CITY OF AUSTIN – DEVELOPMENT SERVICES DEPARTMENT
SITE PLAN APPLICATION – MASTER COMMENT REPORT

CASE NUMBER: SP-2018-0595C
REVISION #: 00 UPDATE: U5
CASE MANAGER: Randall Rouda PHONE #: 512-974-3338

PROJECT NAME: 1303,1311 & 1401 South Lamar
LOCATION: 1401 S LAMAR BLVD W/BLDGS & UNITS

OSHA/Texas Safety Code Working Clearances From Overhead Lines For Unqualified Persons

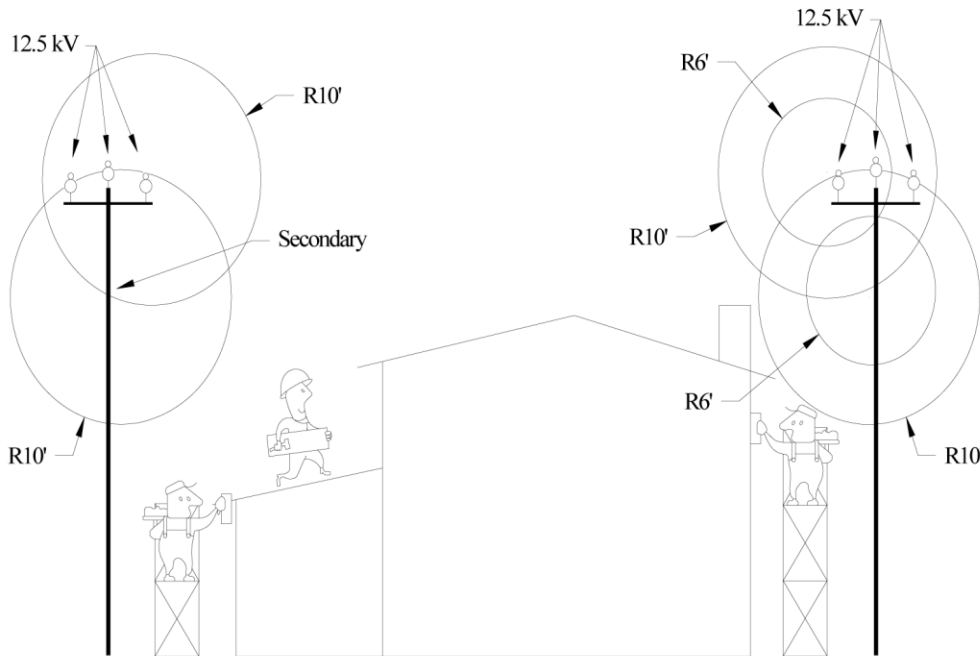
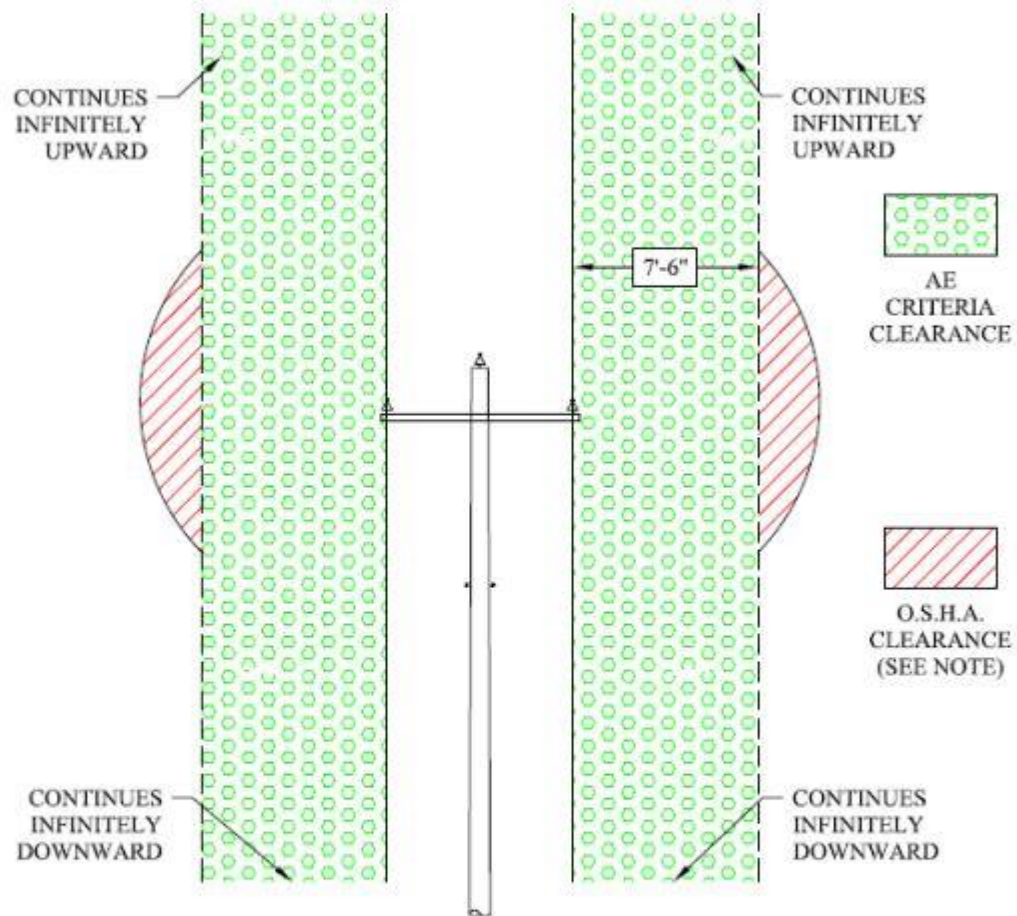
EL 1. The existing overhead facility on the north lot line must be cleared of the proposed building shown. This facility has 4 ft. cross arms from the center of the pole. The following must be shown and building relocated for safety and clearance per AE, NESC and OSHA requirements.

A profile plan of each side of the proposed building including overhangs and balconies and the existing electrical pole include the height with all three conductors/neutral. Link of the criteria manual 1.10.0 - CLEARANCE AND SAFETY REQUIREMENTS: https://library.municode.com/tx/austin/codes/utilities_criteria_manual?nodeId=S1AUENDECR_1.10.0CLSARE
